Meeting: 11/20/2025
Applicant: Steve Young, oysk3 architects
Owner: William Wilson

Location: 1205 Forest Ave. **Parcel ID** 94 L M 010
District: Ft. Sanders NC
Zoning: C-G-2 (General Commercial)
Description: N/A
Vacant lot.

11-B-25-HZ
APPLICATION FOR CERTIFICATE OF APPROPRIATENESS

WILSON PLEX

1 ARCHITECTURAL SITE PLAN
 A100 3/16" = 1'-0"

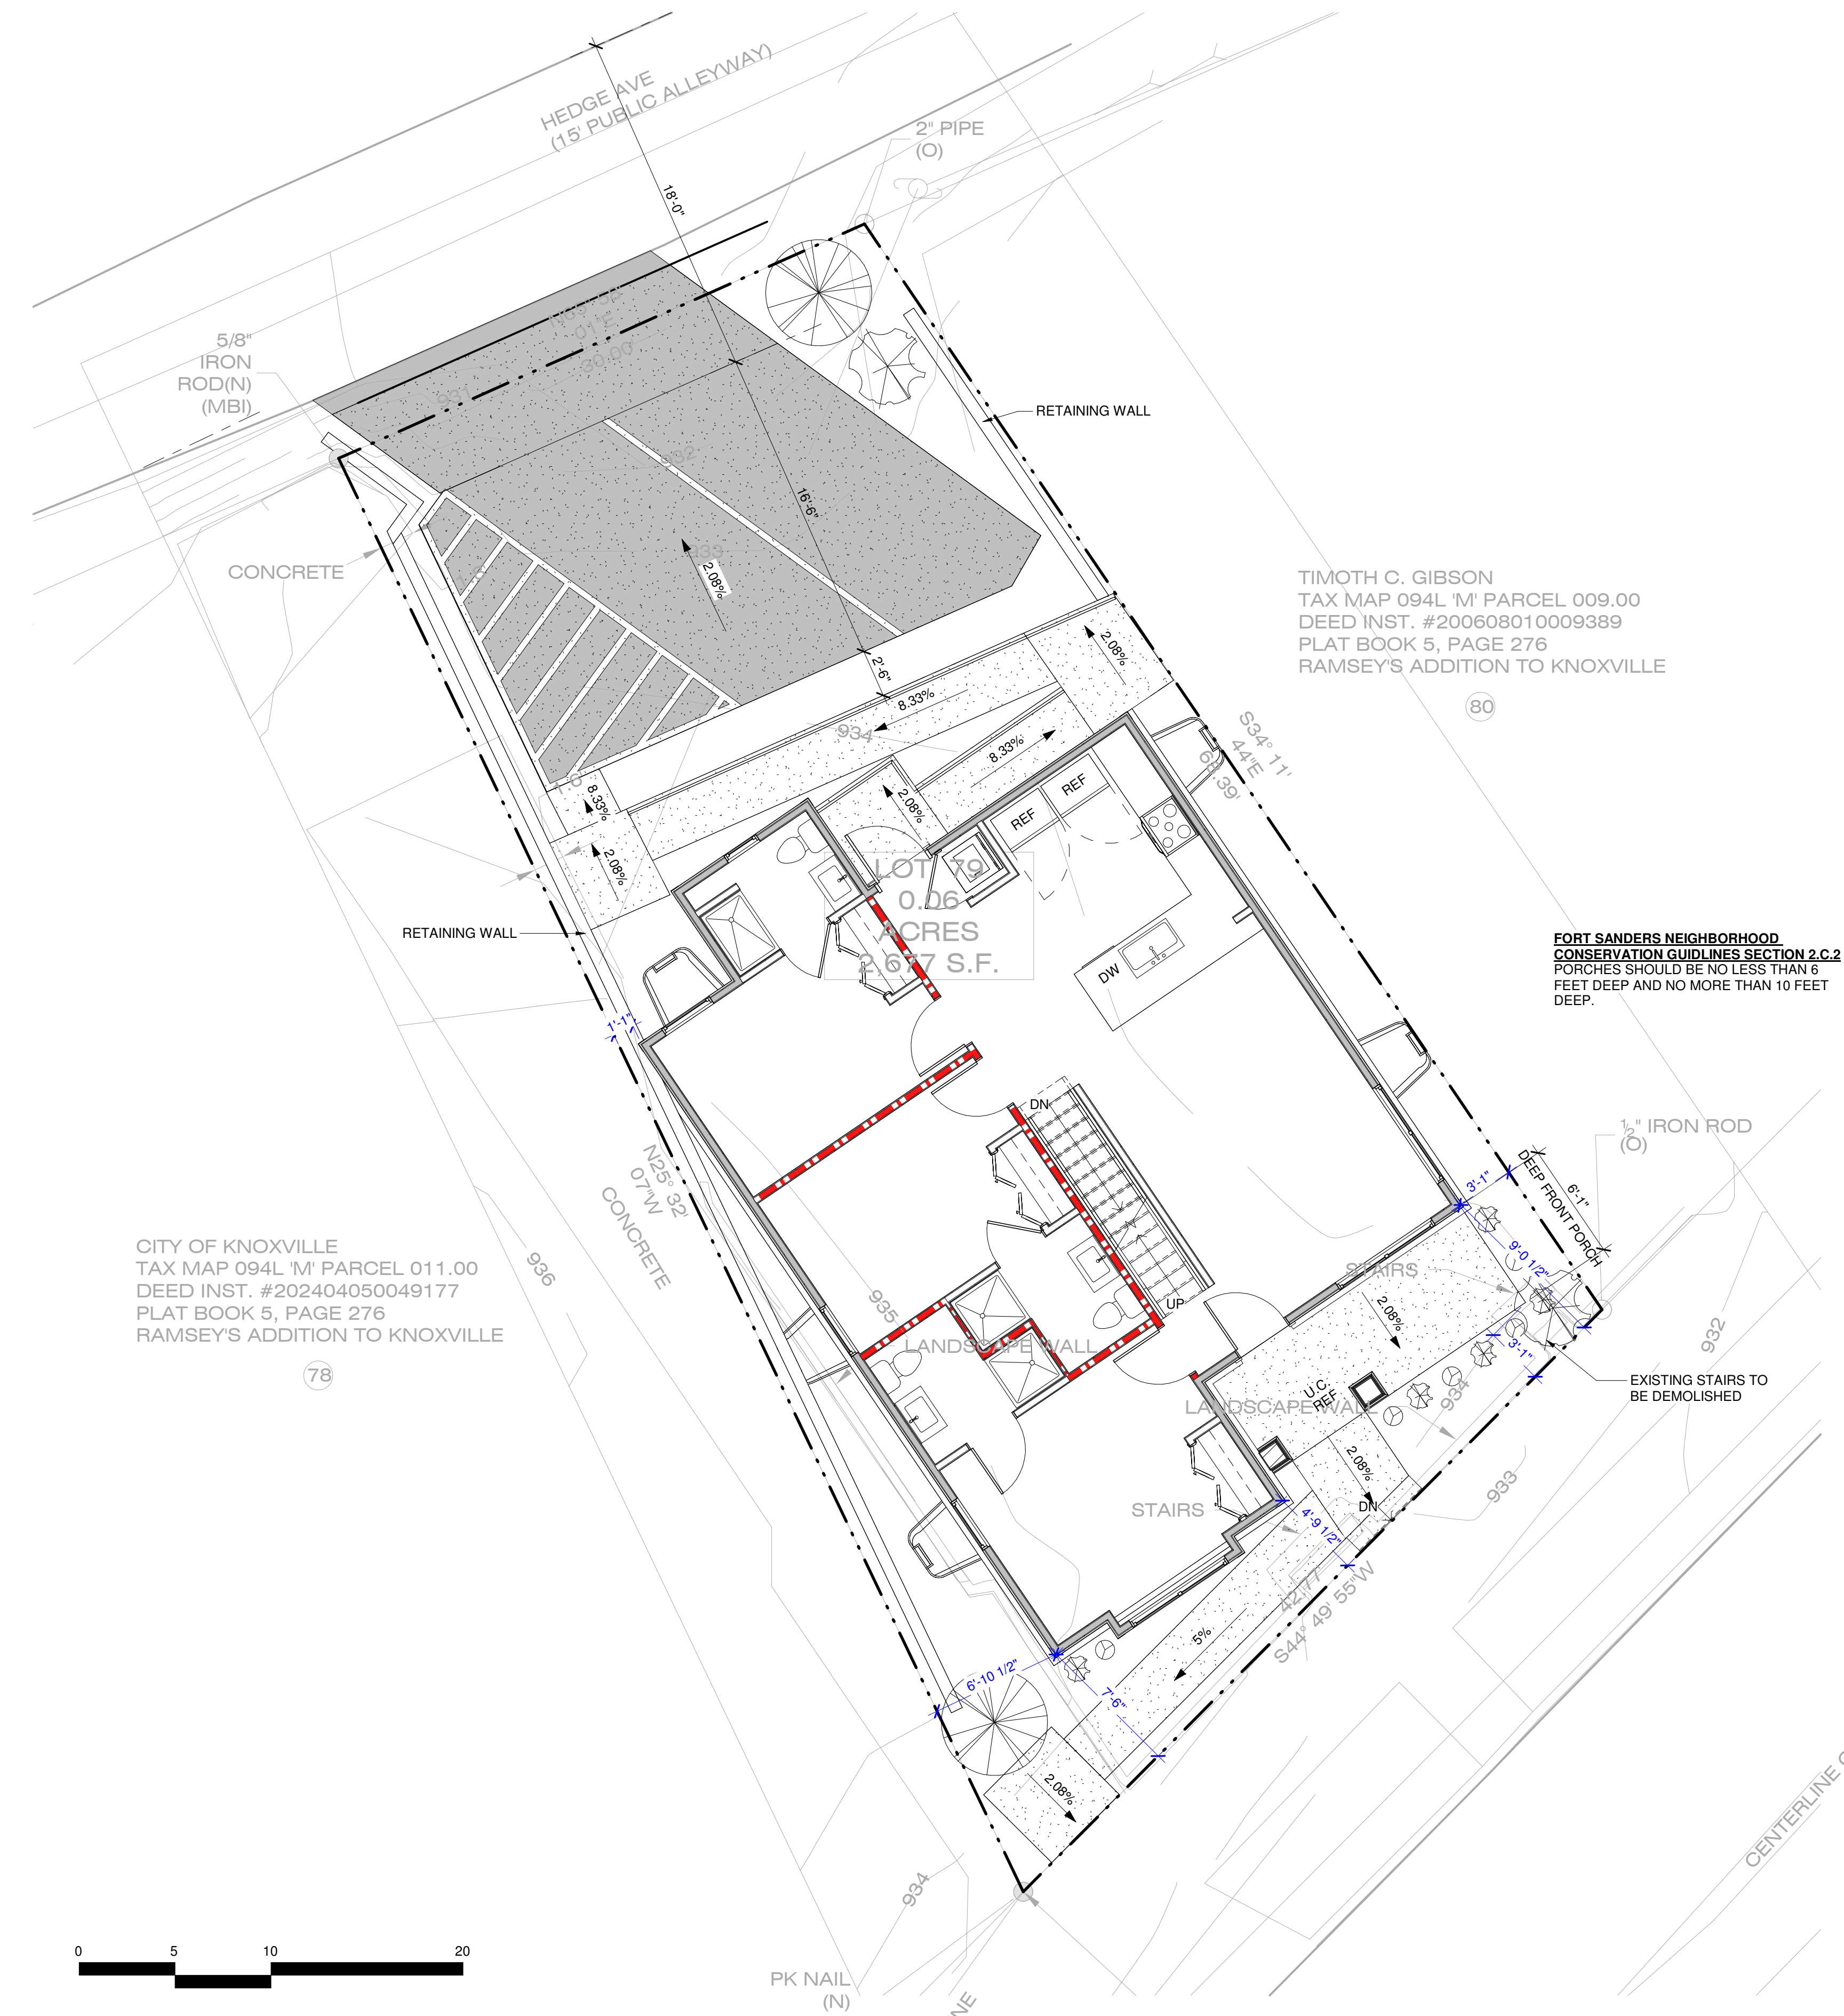
2. Guidelines recommend maintaining the historic façade line of the streetscape and aligning new buildings with the setbacks of pre-1940 buildings on the street. The building will be set 4'-10" from the front lot line, with the porch at 3'-1", but the setbacks vary due to the shape of the lot. The lot is adjacent to a historic building with a 12' front setback, but there was a historic building with a 1' front setback that was demolished by Codes Enforcement in August 2024, which featured a 10' front setback. Although the building would be closer to the street than the previous structure, the proposed front setback aligns with the historic development pattern of the blockface. The narrow side setbacks are consistent with the block.

3. The proposed parking pad at the rear of the lot and accessed via the rear named alley meets guidelines for placement and size, but the angle will likely need to be flipped to meet City Engineering requirements. The site plan includes the native shade trees, ornamental trees, and shrubs near the foundation that are recommended by the design guidelines. The retaining wall will be made from "concrete," but the plans do not specify if this is poured concrete or concrete block. Design guidelines discourage the use of "cinder block" and encourage that retaining walls be made from "low, square cut stone, poured concrete or brick." The retaining wall should be made from poured concrete or be finished with another recommended material, and the final site plan should meet City Engineering standards, with minor revisions to be approved by staff.

- 1) final site plan to meet City Engineering standards, with minor revisions to be approved by staff;
- 2) the retaining wall be made from poured concrete or to have a brick or stone finish, to be approved by staff;
- 3) meeting all applicable standards of the Zoning code and building codes, with minor revisions to be approved by staff;
- 4) extending the first-story front-porch roof to the edge of the concrete patio, with revised drawings to be approved by staff; and
- 5) retaining details as depicted, including brick veneer foundation, window trim, door trim, roof trim, corbelled brackets, porch columns and architrave, and scalloped siding.

1 FRONT ELEVATION
 A201 1/4" = 1'-0"

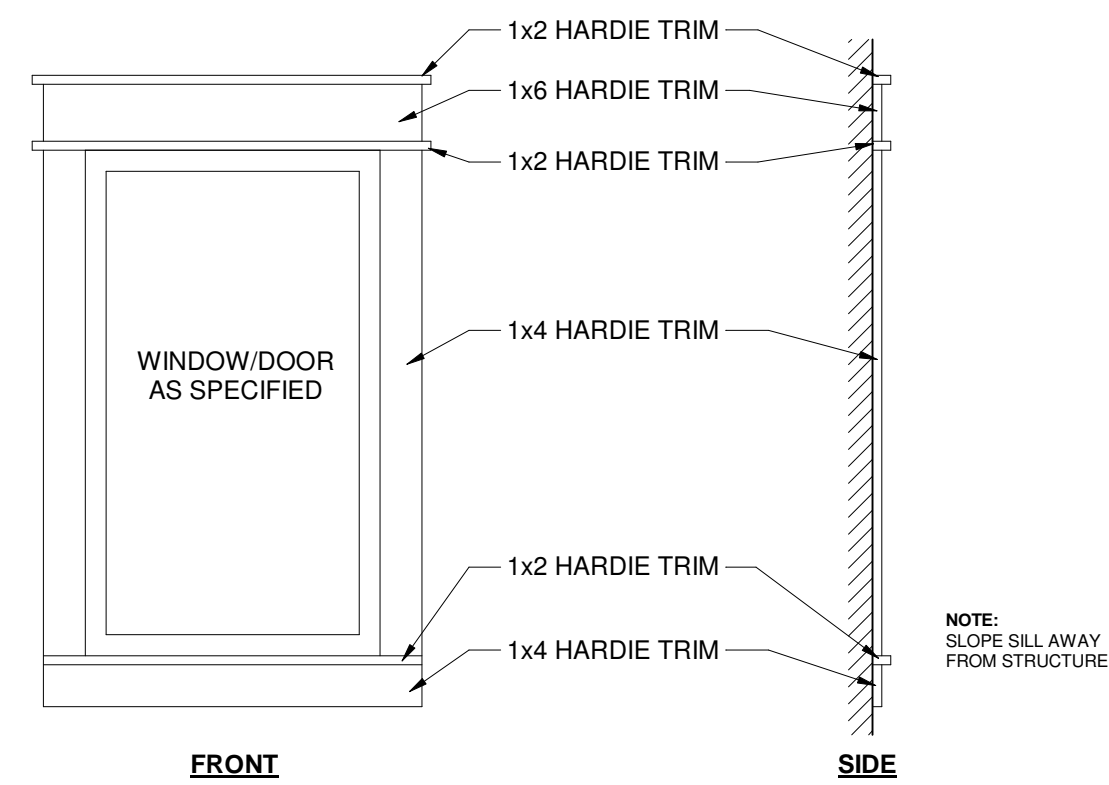
5. The cross-gable roof clad in dark architectural asphalt shingles features an 8/12 pitch side-gable and a 17/12 pitch

front-gable. The form, pitch, and complexity are appropriate, as the guidelines recommend that new construction feature “variations in the form of the roof above the second story such as gables at different angles” and have at least an 8/12 pitch roof.

6. Guidelines for porches recommend that new construction “Provide porches with proportions and materials that complement pre-1940 housing” that “should be no less than 6 feet deep and no more than 10 feet deep” and “may be recessed behind the main setback line or alternatively can extend 10 feet into the front setback line.” However, guidelines for “Traditional Lot Development” recommend that “Porches should extend 8 to 10 feet into the front yard setback.” The design includes a 6’-1” deep, half-length concrete patio on the façade accessed via steps and a small access ramp, and half of this patio is covered to create a two-story front-porch recessed under a side-gable roof that projects from the left bay. The porch is supported by two 11”, tapered, square, Tuscan-order columns on each story that terminate in an architrave on the first-story and a frieze on the second; the second-story features a metal handrailing with curved balusters.

The porch does not project into the front setback, as recommended by some of the guidelines, and 6’-1” is close to the minimum depth recommended by the guidelines. Most of the historic houses in the area feature full-length or half-length covered front porches with supports compatible with and similar to the proposed Tuscan-order columns. The proposed columns and metal handrailing are appropriate. The Board should discuss the porch depth and whether the first-story roof should be extended to cover all the proposed patio.

8. Guidelines recommend that windows on new construction feature similar placement, proportions, and profiles to pre-1940 construction, encouraging the use of double-hung windows. The design employs 4/4 and 2/2 double-hung windows with articulated trim and sills, which meet the guidelines; the material is not specified, but no window materials are discouraged by the guidelines. Overall, the window placement and sizing reflect that of historic structures, and there are a similar number of windows on both stories, as recommended. In the opinion of staff, all elevations feature sufficient transparency, although there is less transparency on the rear elevation, which will be visible from Hedge Avenue, a named alley.

9. Guidelines recommend that new construction feature doors with similar proportions and features to pre-1940 architecture. The quarter-lite paneled door and half-lite paneled door on the façade are compatible with historic styles, and the access ramp leading to the primary entrance is small in scale. The full-lite door on the rear elevation accessed via an access ramp is not a historic form but is clearly secondary in nature and is compatible with the context.
